SAF UltraLite Trailer Mechanical Slider Suspensions

Product Change Notice for SAF Mechanical Trailer Slider Suspension Sub-frame

Effective with shipments November 2012

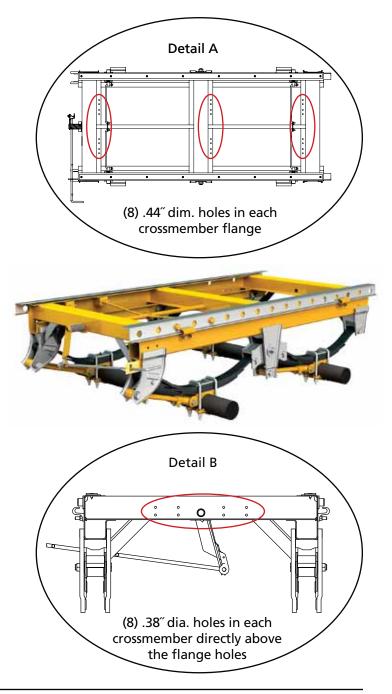
SAF-HOLLAND has added a series of holes to each sub-frame crossmember of our UltraLite mechanical slider suspension. These holes have been added to make for easier installation of various bolt-on component options (i.e. lightweight control boxes, ABS control boxes, etc.).

A total of 48 holes have been added to the crossmembers – (8) .44["] diameter holes have been added to each crossmember horizontal flange (see detail A for hole locations), and (8) .38["] diameter holes have been added to the rear vertical face of the front and middle crossmembers, and the front vertical face of the rear crossmember (see detail B for hole locations). These holes do not change the form, fit or function of the slider sub-frame.
